IEEE P802.3dg2.1

Miscellaneous changes

Peter Jones, Cisco Systems

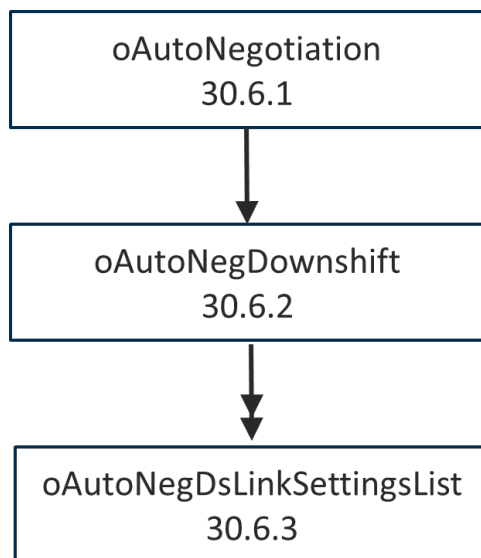
Change Figure 30–3 by adding oAutoNegDownshift and oAutoNegDsLinkSettingsList within oAutoNegotiation as follows:.

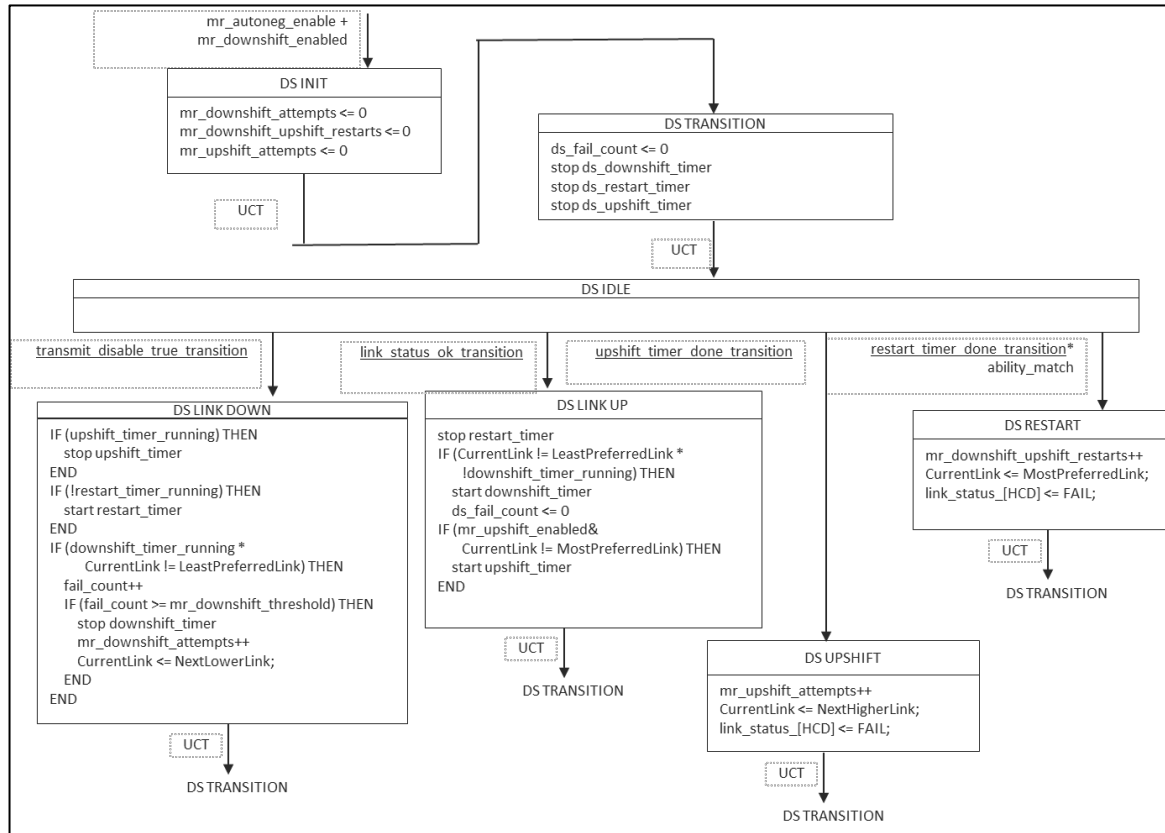
Replace Figure 98D-1—Downshift state diagram with the following(updated from jones_3dg_d2p1_downshift_0.pdf with name changes):
